**Planning Commission Hearing
Staff Report
Hearing Date: September 23,
2020**

ITEM #6 D. R. Horton, Inc. requests Concept Plan approval for a townhome development, located at 1920 S 500 W in a proposed Low Density Residential (LDR) zone. Lakewood Neighborhood. Aaron Ardmore (801) 852-6404 aardmore@provo.org PLCP20190188

ATTACHMENT 1 – PROPOSED SITE PLAN

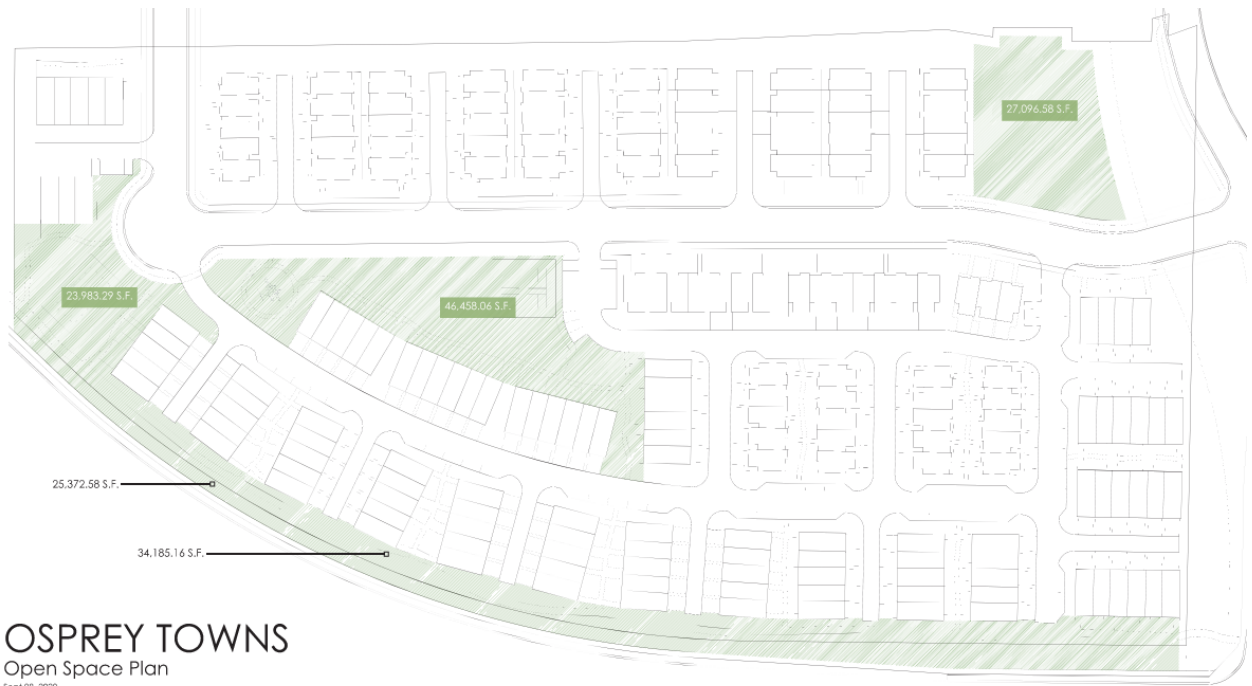
The proposed plan is a result of staff working through zoning and infrastructure issues for the past year over several redraws for the site. This plan has met design standards of Section 14.34.287 with units addressing the streets, the mix of materials and colors, and pedestrian connections. As shown in the attached proposed elevations, the applicant has provided a mix of cement fiber patterns and siding as the major materials, leaving stucco at or below the maximum 20% allowed on the face of the buildings. This variety meets standards for the allowed major and minor materials as written in subsection 14.34.287(9).

Staff has also reviewed the proposed plan against the LDR zone, and has found the density standards, parking supply, and open space amenities meet the proposed zone. With 195 units and 807 parking spaces, the overall project will be parked at a rate of 4.1 spaces/unit. This parking supply exceeds what the City would require, and staff would support a reduction of the additional stalls near the pickleball court. However, 195 two- and three-bedroom units would demand three (3) spaces per unit, so the excess

Staff recommends that the proposed Concept Plan be approved, subject to the approval of a zone change to LDR and recording of the Development Agreement.
